ADB TA 8053BAN:

Preparing the Khilkhhet Water Treatment Plant Project

Final Report

Revised to reflect change of WTP location to Gandharbpur

Figure 7: Typical Pipe Corridor

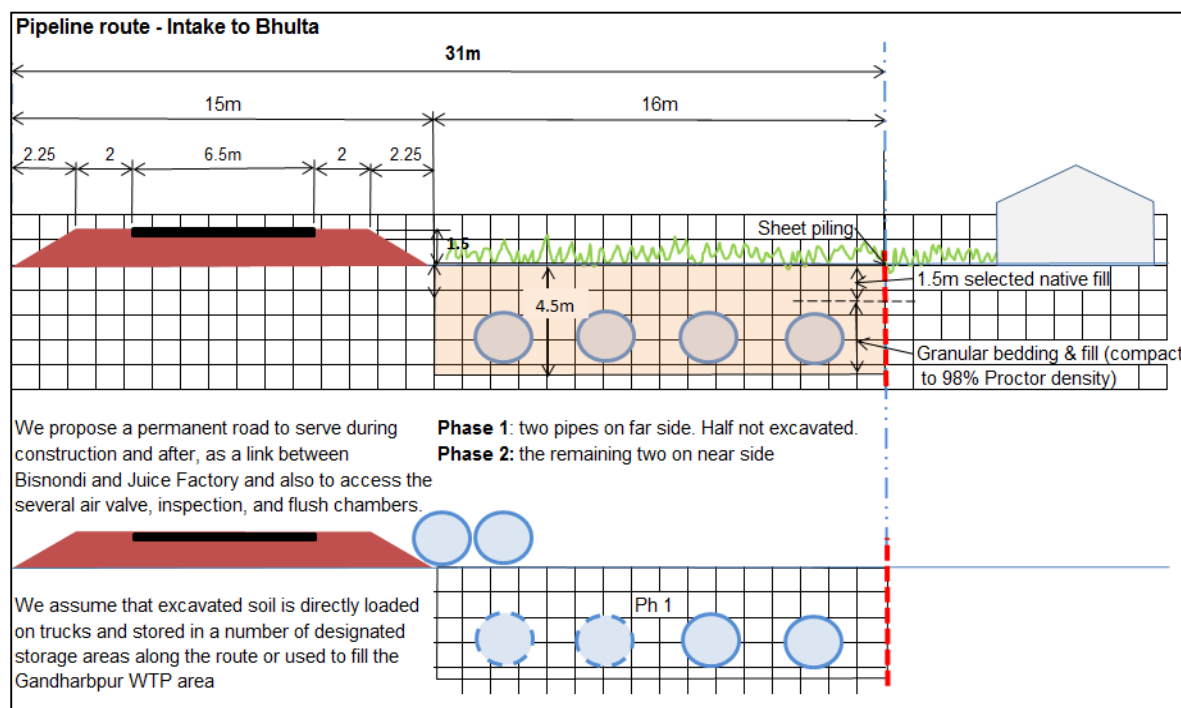
170. As noted and illustrated in Figure 7, we disagree with the width required to construct a permanent service road and ultimately, four 2200mm diameter pipelines in a 24m corridor.
